Sydney North Planning Panel

Panel No	2017SNH014
DA Number	LDA 2016/0524
Local Government Area	City of Ryde
Proposed Development	• Demolition of the two existing commercial buildings on site, excavation to create three basement levels, and site remediation works. • Construction of a Part 17 and Part 21 storey residential flat building (referred to as 'Building 1'), and a Part 19 and Part 21 storey residential flat building (referred to as 'Building 2'). • Provision of 412 dwellings and 360 car parking spaces. • Three ground floor retail tenancies with a total of 259m² gross floor area (GFA) on Waterloo Road and corner of Byfield Street.
Street Address	80 Waterloo Road & 16 Byfield Street, Macquarie Park
Applicant	Time & Place
Number of Submissions	2 submissions received.
Regional Development Criteria (Schedule 4A of the Act)	General Development over \$20 Million – Cost of works: \$154,000,000
List of All Relevant s79C(1)(a) Matters	• Environmental Planning and Assessment Regulation 2000; • Environmental Planning and Assessment Act 1979; • Statement Environmental Planning Policy (State & Regional Development) 2011 • State Environmental Planning Policy No. 55 – Remediation of Land; •

Figure 12 illustrates the original design with the smaller separation & **Figure 13** illustrates the changes as recommended by the Panel.

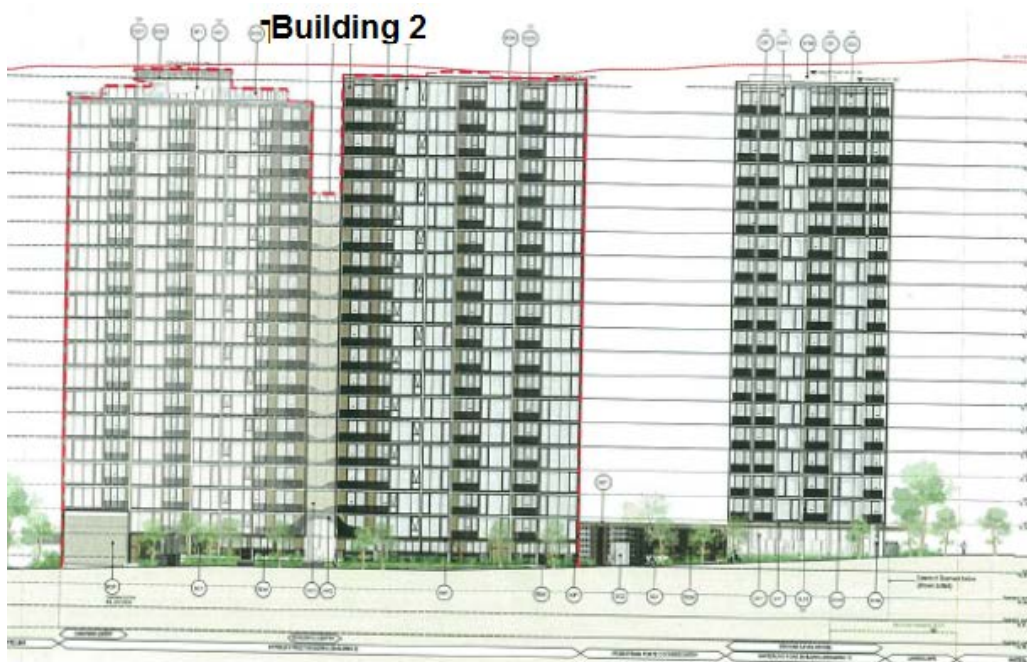
This change in combination with lowering the height of the bridging element to level 9 will make a significant improvement to the perception of reduced length.

The proposal has been amended to increase the separation in Building 2 by 1.8m. Also the bridge has been removed from levels 10-14, increasing the proportion of the separated components of the building by 5 storeys. Building 2 has been further articulated as a stepped facade along the entry to the foyer and is now 6m apart at the narrowness point, for a distance of 6.9m. The new staggered façade now directs the primary outlook of the bedrooms away from the building and towards the street or landscape podium, thereby increasing privacy and amenity. The applicant has amended Building 2 as recommended by the Panel.

Figure 13: Amended design with reduce number of storeys and greater separation in the gap area of Building2.

Figure 16: Amended proposal with increased gap separation and staggered façade. Red dotted line outline original proposal.

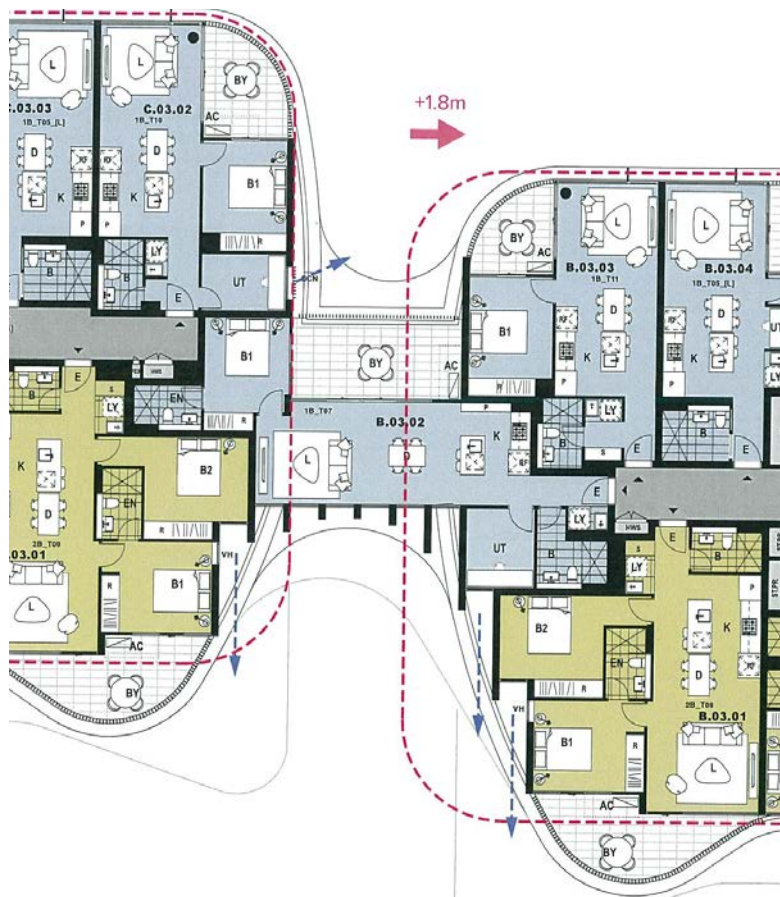
Other units such as those similar to C.01.01 and B.01.01 have bedroom windows in very close proximity to each other in the gap. This is not a sufficient separation to achieve either visual or acoustic privacy and the width and depth of the slot is poorly configured to provide an appropriate outlook or amenity for habitable rooms unless windows are secondary.

Figure 15: Amended proposal with increased separation, stepped façade which directs the outlook away from the building.

Figure 17: Privacy screen provide to redirect the primary outlook towards the garden.

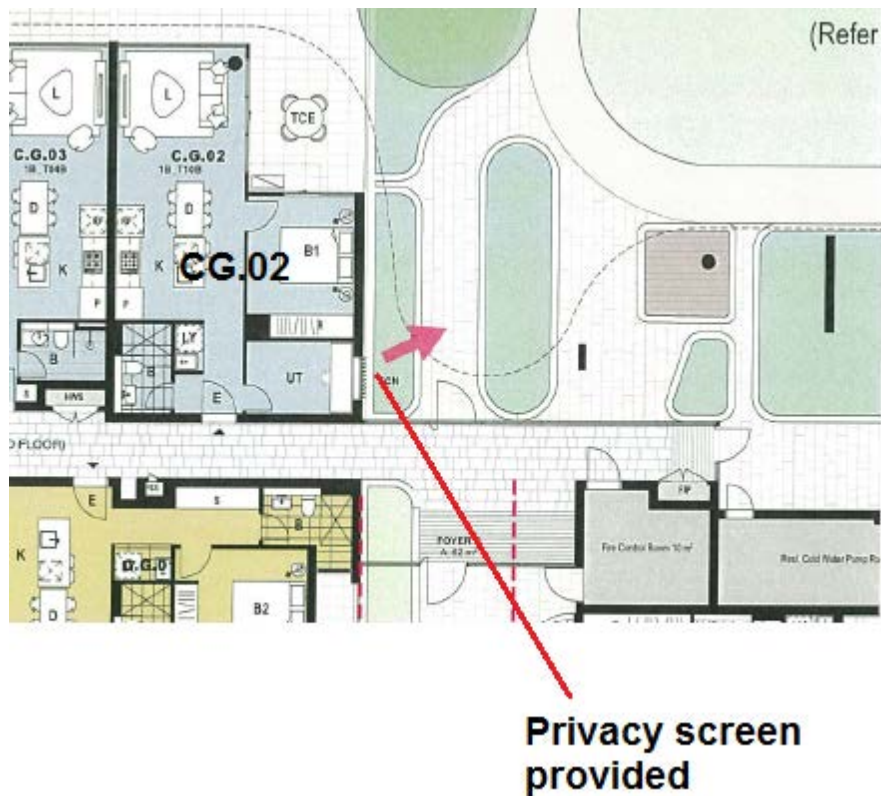
Unit CG.02 has been reconfigured to include a privacy screen to minimise overlooking to the public courtyard area. See **Figure 17**

Figure 18. The “colonnade” arrangement of Unit BG.03 has been amended as recommended by the Panel.

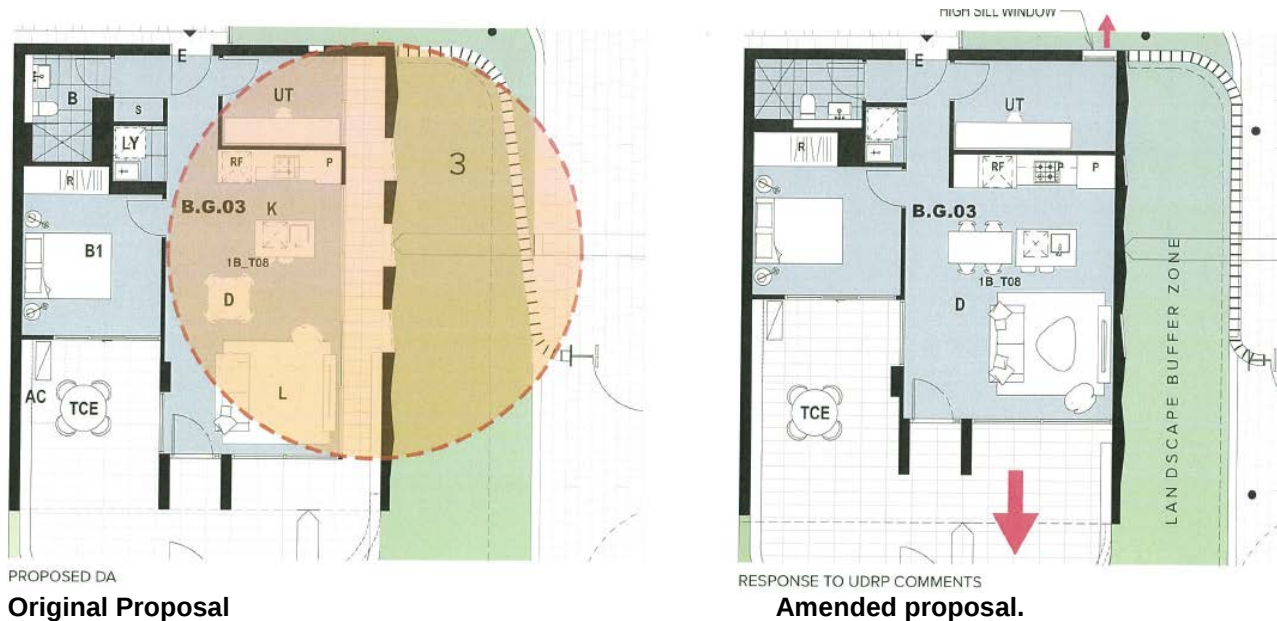
Unit BG.03 has been redesigned to absorb the area of the veranda as recommended by the Panel. See **Figure 18**.

Figure 25: Height plane 3D diagram as viewed from southeast.

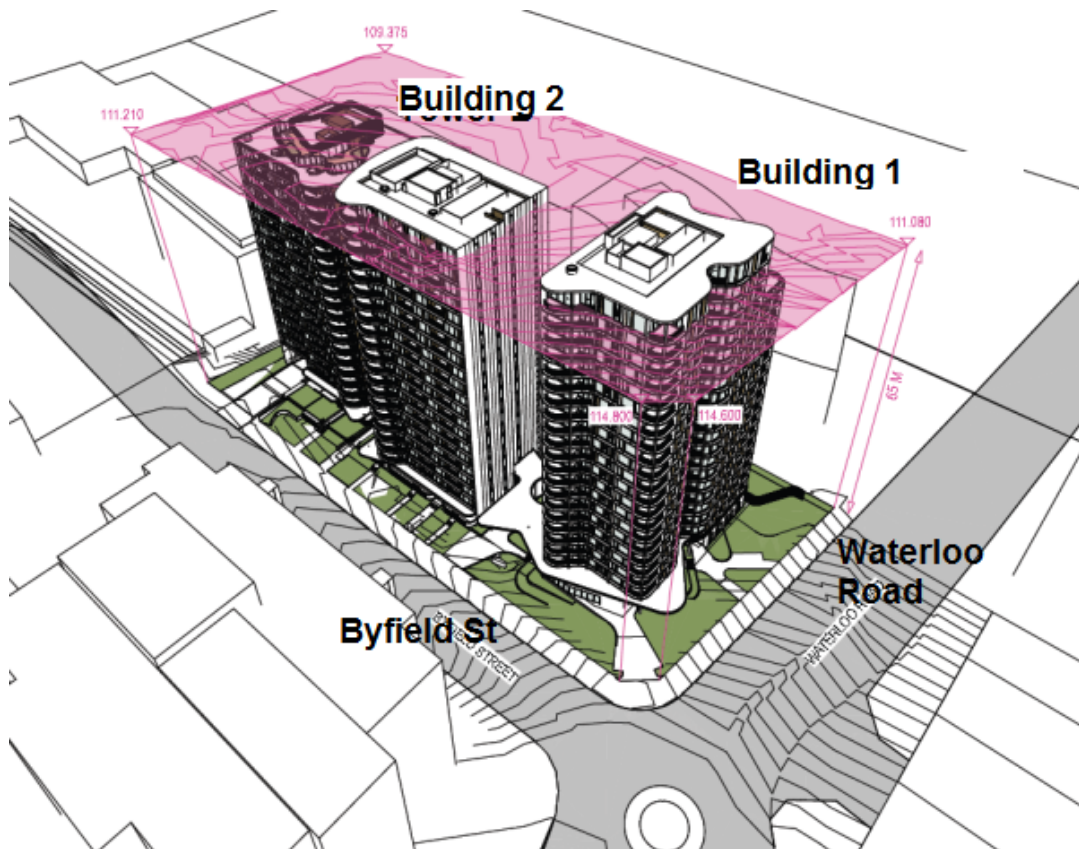
The maximum height allowed is 65m. The proposed development will result in one additional storey above the maximum height for Building 1 and additional half storey above the maximum for Building 2, a variation of between 10.7% & 6.46% for top of plant rooms and 4.5% & to 8.7% for top of buildings as shown at **Figures 25 & 26**.

Figure 28: Shadow diagram at 21 June 9am. The red outline show the shadow cast by the original proposal which was height compliant and the light blue is the additional shadow by the added height.

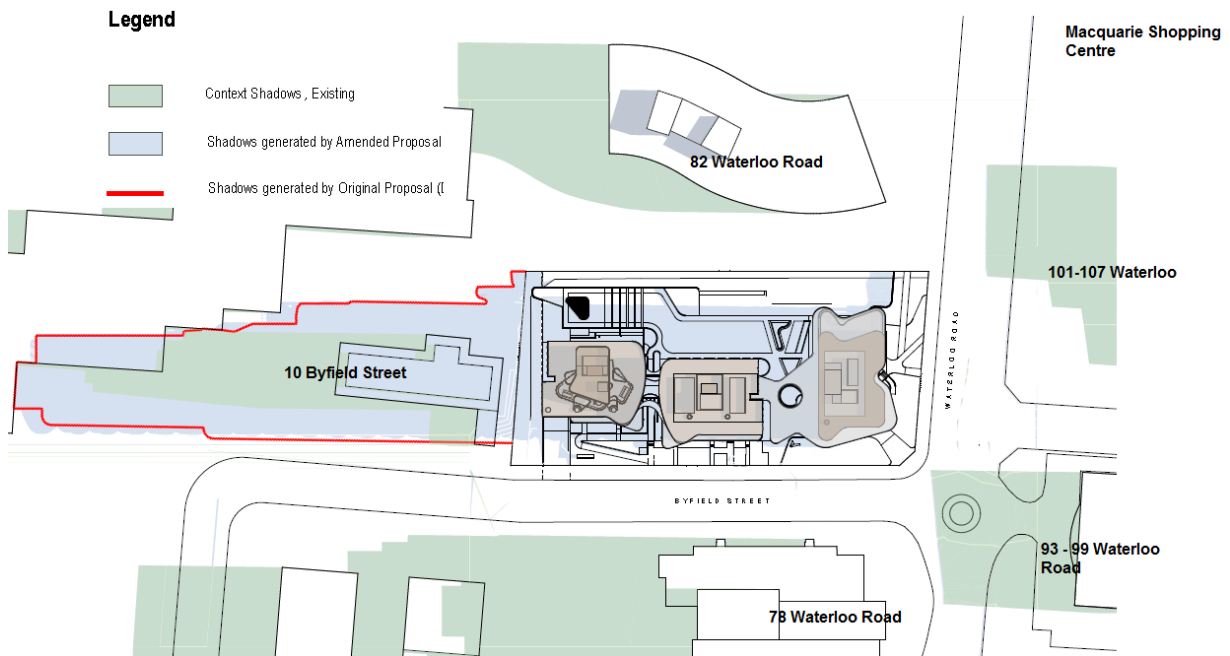
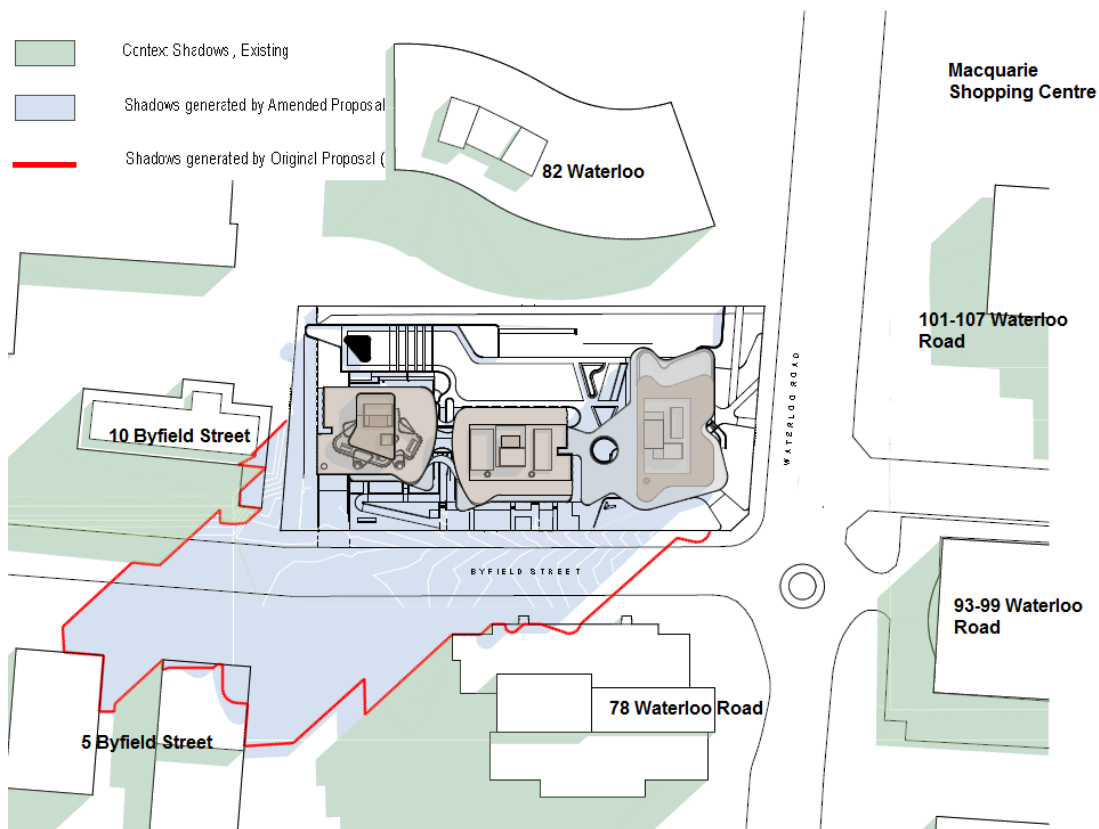
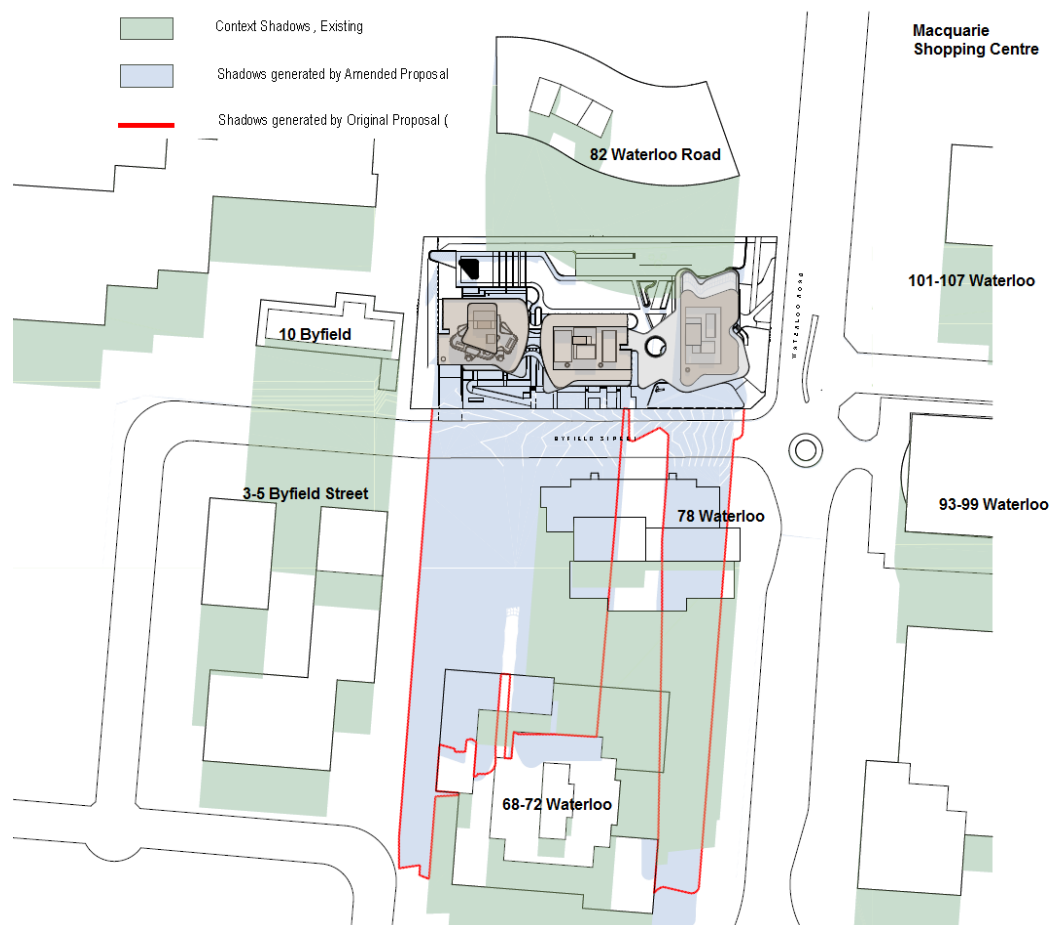
The development is unlikely to result in any significant increase in overshadowing onto the surrounding residential buildings or open spaces. The subject site has an east west orientation with overshadowing occurring on the adjoining commercial property at 10 Byfield Street which contains a 9 storey building - Holiday Express Inn. Due to the orientation of the land, this adjoining site will received the required solar access in the afternoon from 12 noon onwards.

The properties to the south, opposite along Byfield Street, 3, 5, 7-9 Byfield Street and 78 Waterloo Road are commercial properties and will benefit from the morning sun. Due to the orientation of the land, these properties will not be overshadowed by the development in the morning thereby receiving the required solar access in the morning from 9am to 12 noon, the required 3 hours solar access. See solar access diagrams **Figures 28 to 30** below.

Figure 32: Additional blade added to minimise overlooking from the balcony area to the bedrooms.

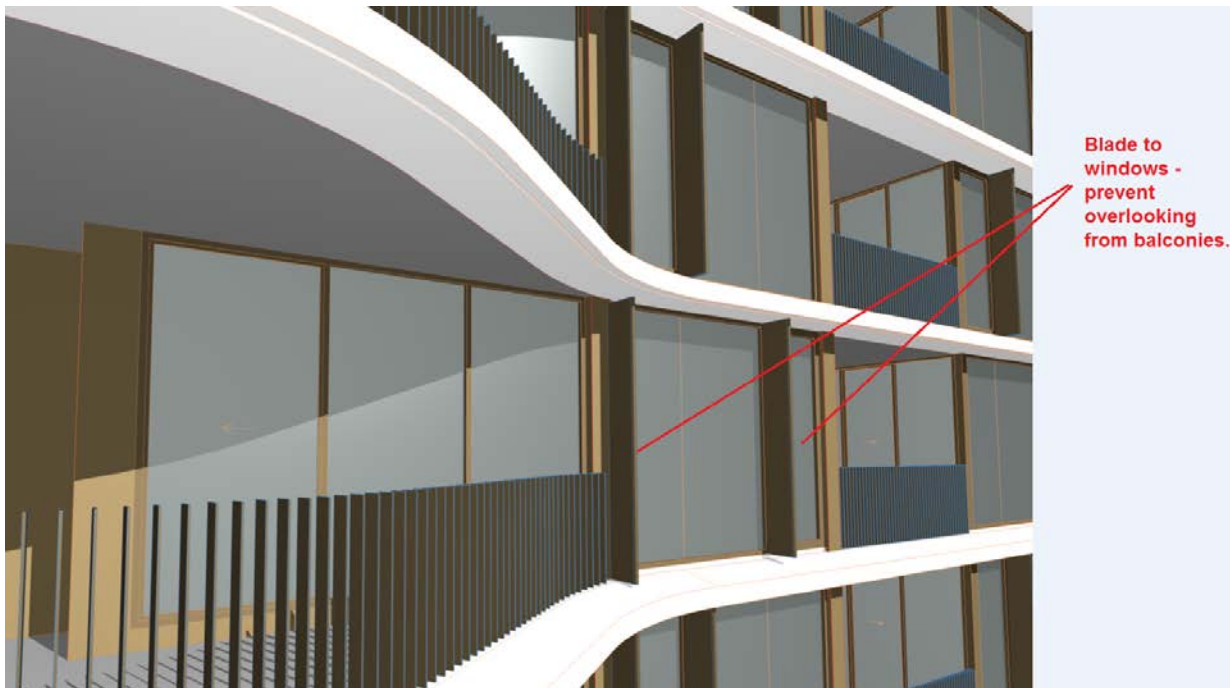
The balconies from unit B01 and C01 allow serious overlooking into adjacent units (B07 & C07), and the units below. According to the plan, when a person stands at the widest part of the balcony, he/she can see the bedroom, balcony, and living area of the adjacent units.

The applicant has advised that this can be addressed by the imposition of another blade adjacent to the bedroom window. This will help with privacy from the balconies whilst still maintaining the design intent. **Condition 1(c)** has been imposed to address this issue.
